AX84 http://www.ax84.com

The Cooperative Tube Guitar Amp Project

Title: **High Octane Schematic**

Sheet 3 Of 3 | Revision: 06.02.23

06 **Variable Cathode Bias Option**

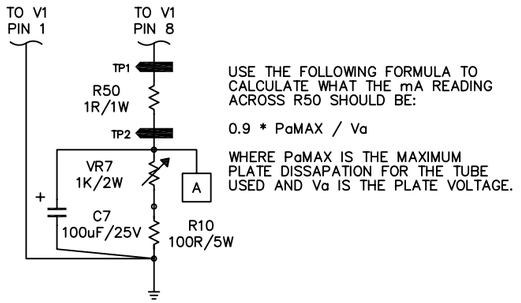
Revision	Description
05.11.23	Vari-Bias Revisions Mute Switch Is Now An Option Revised Detail 01 R/C Numbers Revised Detail 04 R/C Numbers
06.02.23	Added Parallel Octal Output Stage Re-numberd Valves Modified Variable Bias Detail Modified Mute Switch Detail Modified 6N1P Output Detail Modified Filament Hookup For Octal Socket Changed R24 to 10K Tone Stack Wiring Correction Removed General Note 6
